**ACP-2021-078**

**Enabling Remotely Piloted Aircraft Operations from RAF  
Fairford - HALE**

**EGD218 Modification Request**

Figure 2 Proposed Change to EGD 218 Complex

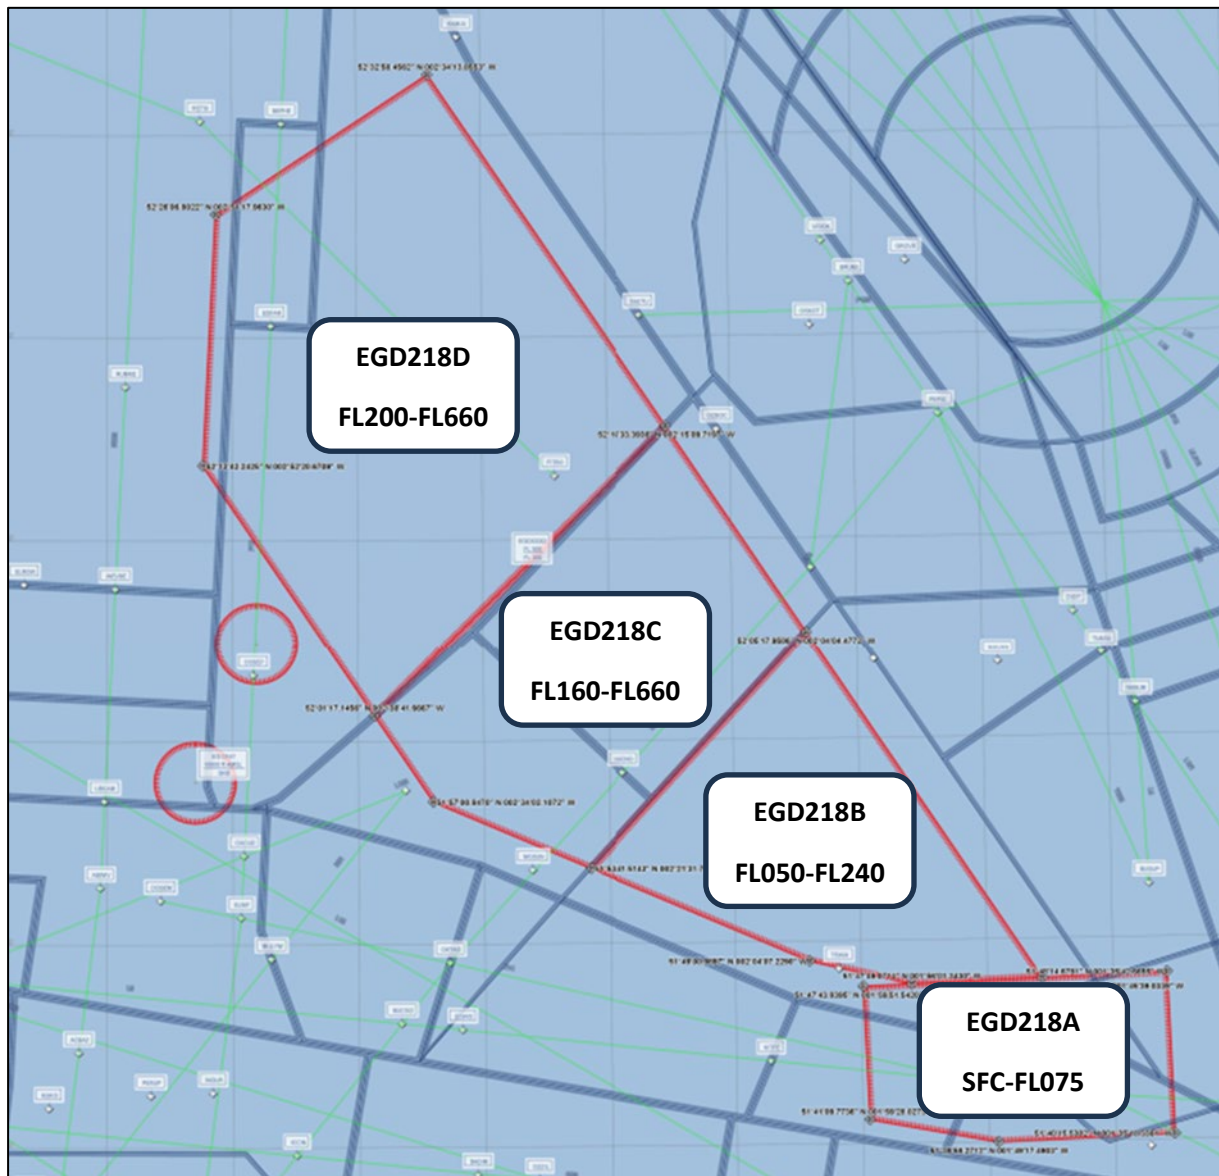
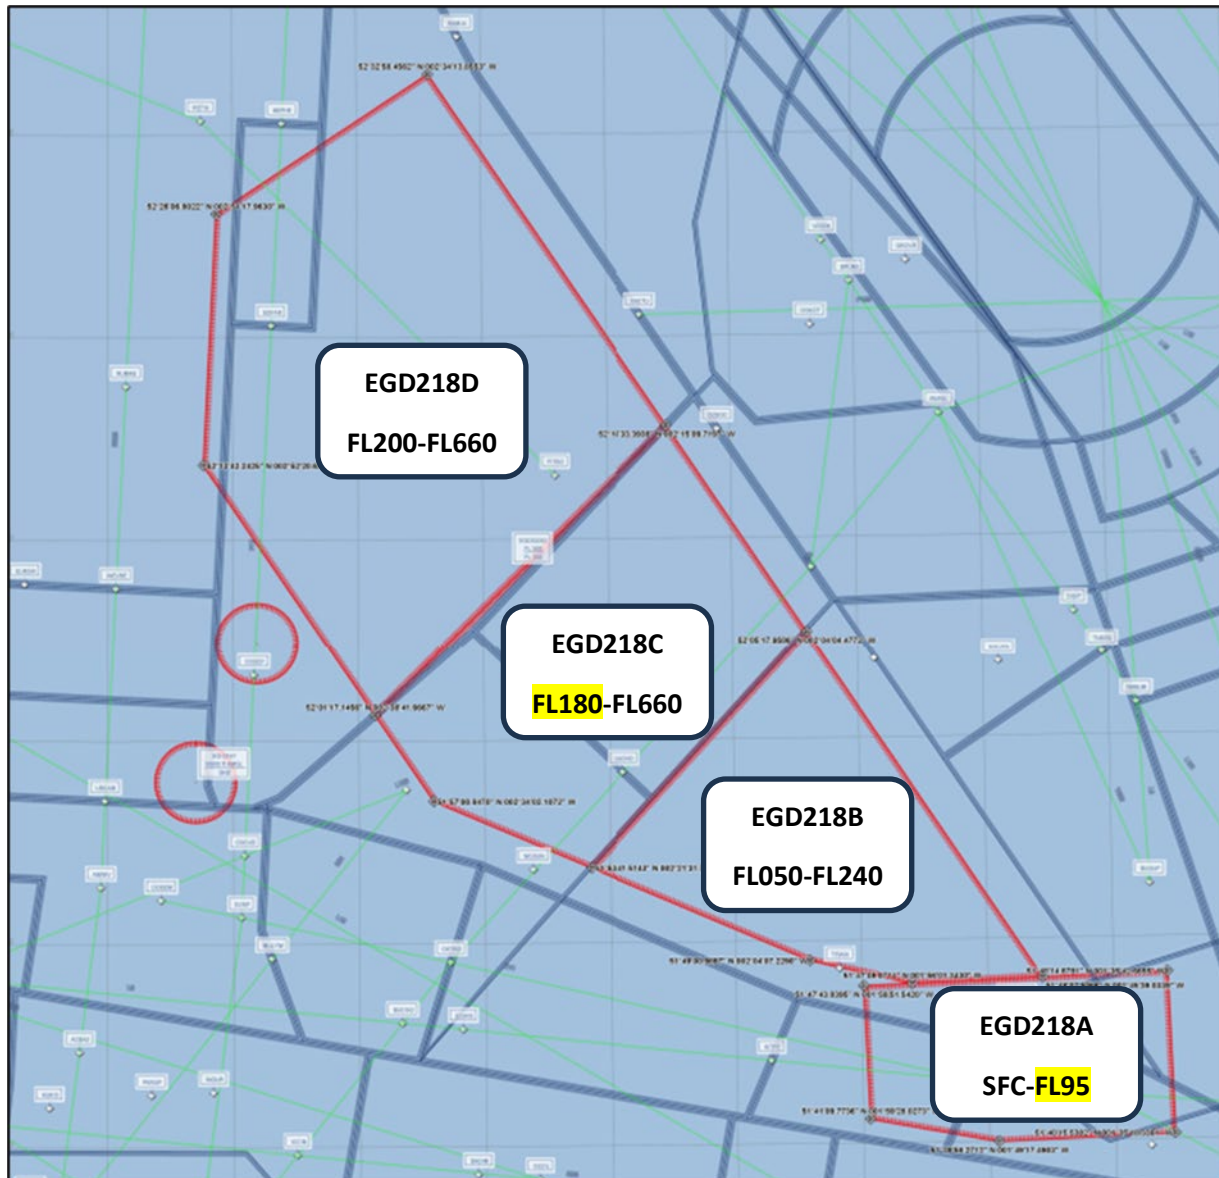
The lateral dimensions of the EGD218 complex will remain unchanged. The proposed modification involves raising the floor of EGD218C from FL160 to FL180 and raising the ceiling of EGD218A from FL075 to FL095.

The Sponsor has continued engagement with NATS and developed a solution that is expected to eliminate the impacts to Birmingham Airport arrivals detailed in the 1 October 2024 PIR report. This solution proposes raising the ceiling of EGD218A from FL075 to FL095, which would, in turn, allow the floor of EGD218C to be raised to FL180.

*Figure 4 Proposed Change to EGD 218 Complex and Proximity to Adjacent Airports*

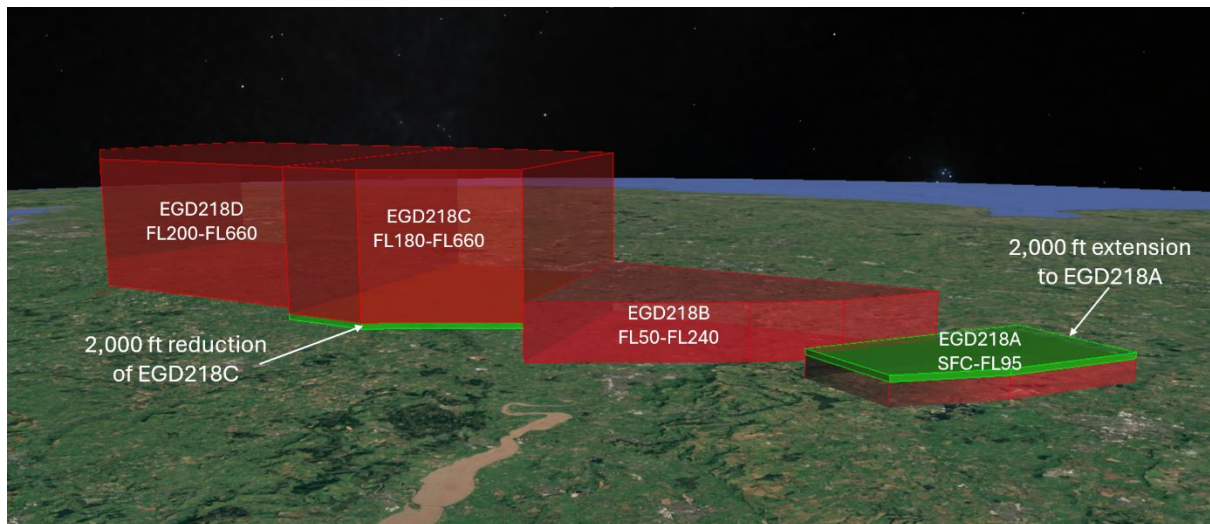
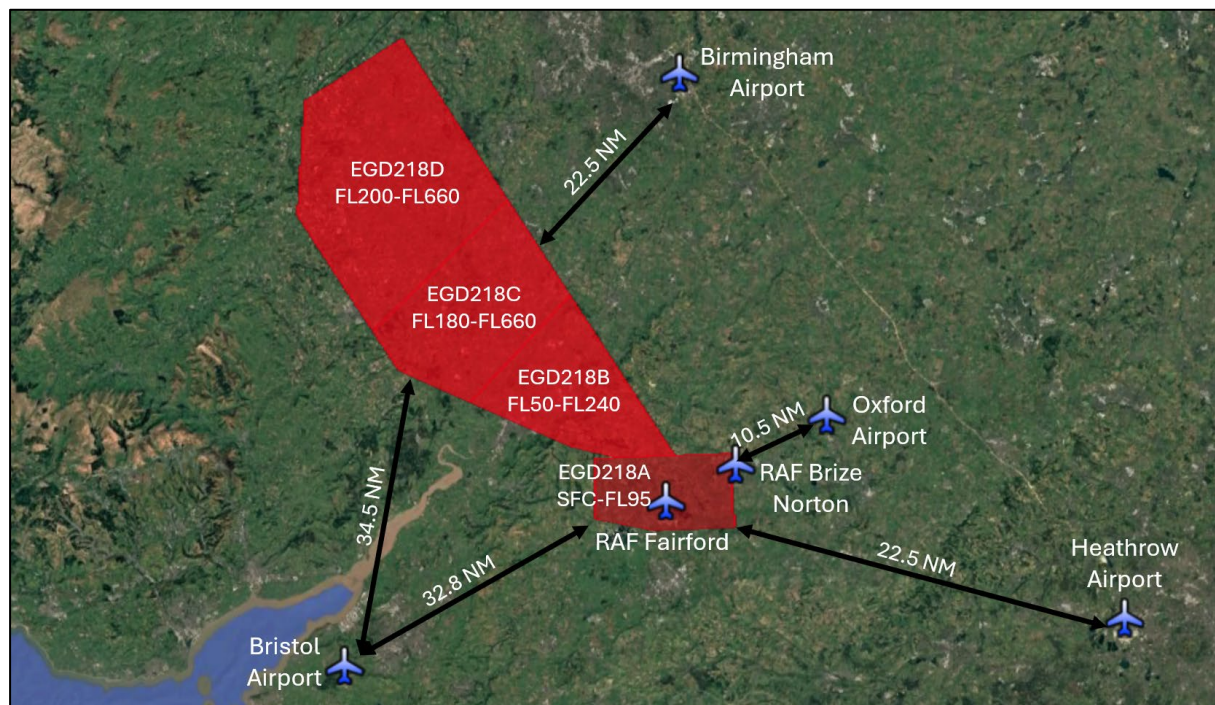
Raising the floor of EGD218C to FL180 will mitigate the impacts to Birmingham Airport by allowing Birmingham Airport arrivals to underfly EGD218C without transiting through airspace delegated to Cardiff. This is Birmingham Airport's preferred solution, as detailed in their 26 September 2024 letter to the Sponsor<sup>3</sup>.
